RICHARD L. MEEHAN

June 16, 2023

Re: Dairi Prima Minerals (DPM) Mine site risks and Tailings disposal safety.
Review of Dairi 2022 EIA Addendum.

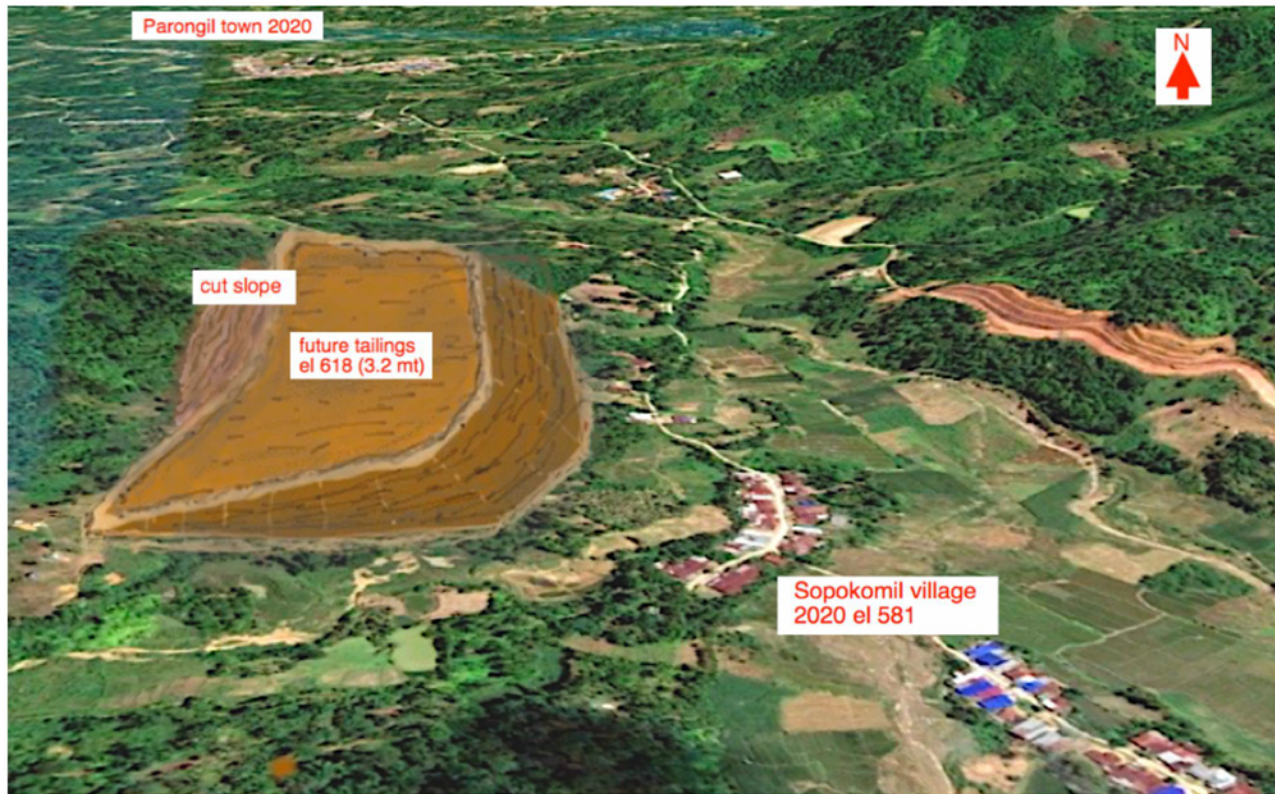
Figure 1. Planned configuration of TSF, 3.2 million tons at elevation 618. TSF configuration (brown color) from EIA Addendum fig 2.22 sketched onto Google Earth image by the author. Breach of the tailings dam above the Sopokomil village is likely in a strong earthquake because the ground between and beneath the village and the TSF and the dam foundation is unstable volcanic ash soils subject to liquefaction.

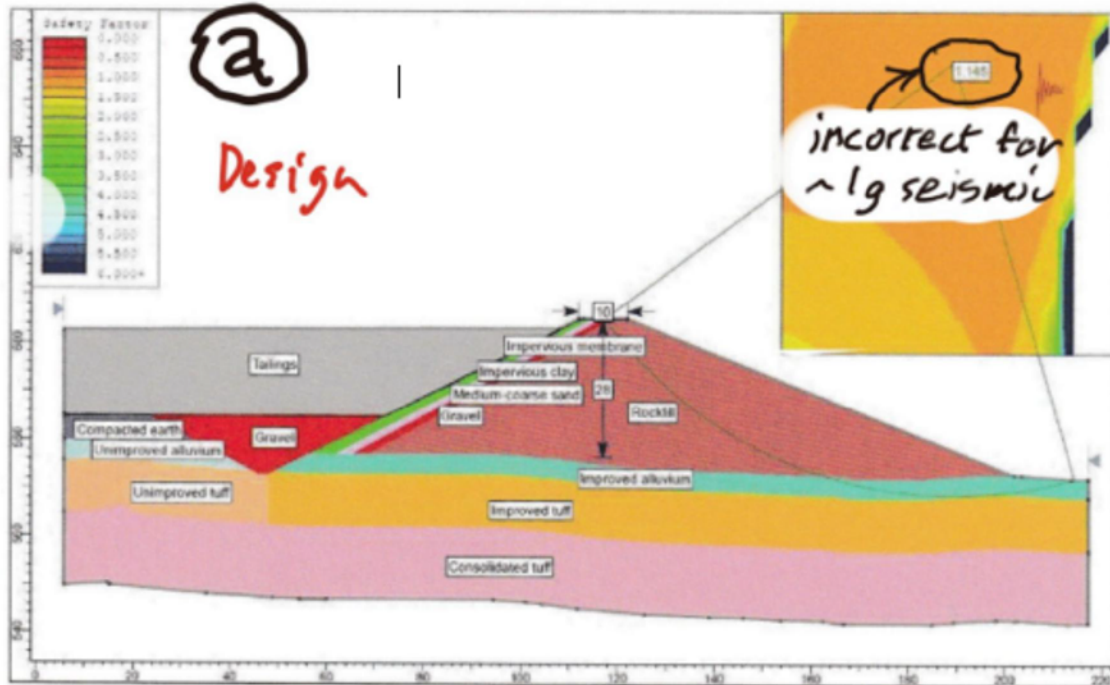
Meanwhile for this 2022 EIA Addendum, DPM, having now come to an admission of the serious seismic safety problems at the site, hired a world-class Indonesian seismologist named Danny Natawidjaja. DPM says that Natawidjaja produced a report saying ground motions with an intensity of 0.5g (.489g) are credible and must be applied at the proposed Tailings Storage Facility site. Though a copy of the Natawidjaja's report has not been made public, **I believe this 0.5g figure is intended to be applicable to bedrock 50 or more meters deep beneath the proposed dam, not to the dam foundation where the most acute and critical problems are likely to develop. Hence the Bishop method stability analysis the DPM advances (but does not document) to argue for stability is incorrect by a large margin.**

It is probable that Prof Natawidjaja, as a seismologist rather than an engineer, has not considered the local soil conditions at the DPM site above bedrock. Normally that knowledge is considered to be within the realm of responsibility and expertise of the project engineer, not the consulting seismologist.

Gambar 2.47 Gambar Perhitungan Nilai FoS Disesuaikan Dengan Kondisi Akhir TSF

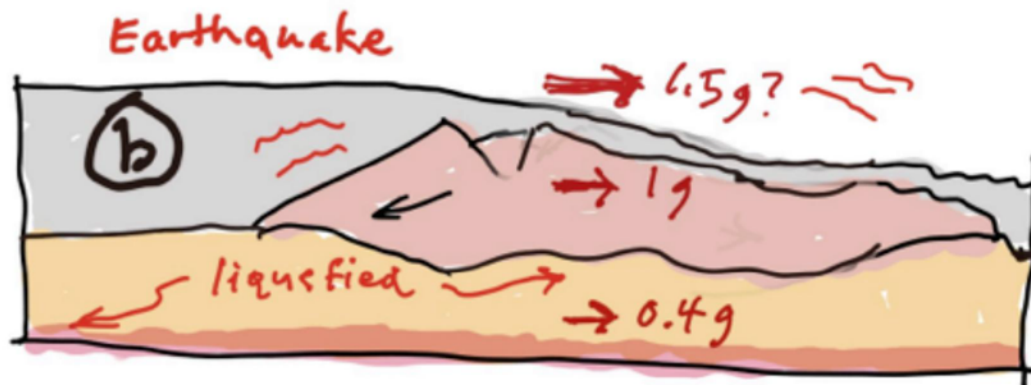
This amplification in the material overlaying the bedrock would invalidate the undocumented seismic stability analysis provided by DPM in EIA Figure 2.47. That figure concludes that the “factor of safety” (which must be more than 1.0), will be 1.03 apparently for Prof Natawidjaja's "maximum credible" earthquake of .489g. However, if site amplification is taken into consideration, the “factor of safety” for DPM’s proposed TSF would be below 1.0, down to even 0.7 (meaning the dam would be considered highly unsafe). Even lower factors of safety would occur if the dam and tailings quantities were higher than that specified in the EIA. Emerman(2023) has conducted a study of surface storage requirements for the TSF and concluded that the EIA significantly underestimates the volume and height of the required TSF. If this proves to be the case, even lower margins of safety will result.

In addition to lowering the factor of safety, failure to consider amplification also results in an incorrect failure configuration such as the one shown on EIA figure 2.47, part A. Amplified ground motion or loss of foundation bearing capacity due to liquefaction would instead flatten the failure surface in a way that causes sinking of the dam as suggested in the sketch, part B herewith.

DPM now claims, without any stated basis, (figure 2.47, extract attached) that unstable ash soil does not extend to depths greater than 16 meters. It may extend deeper, but even 16 m depth, over an area of roughly 100 x 500 m represents 800,000 cubic meters (more than a million tons) of soft volcanic soil that would need to be “improved”. This is more than the volume of the retaining rock fill dam. Removal, replacement, compaction or other form of stabilization of this amount of soil would be in an enormous task and unlikely to be implemented because it would make the project economically infeasible. There is not even any suggestion as to whether this ash *can* be improved by normal recompressive efforts, addition of chemicals, etc. In fact, the EIA Addendum elsewhere indicates that the ash is not suitable for important construction except for road fill because it is “soft volcanic eruption”.
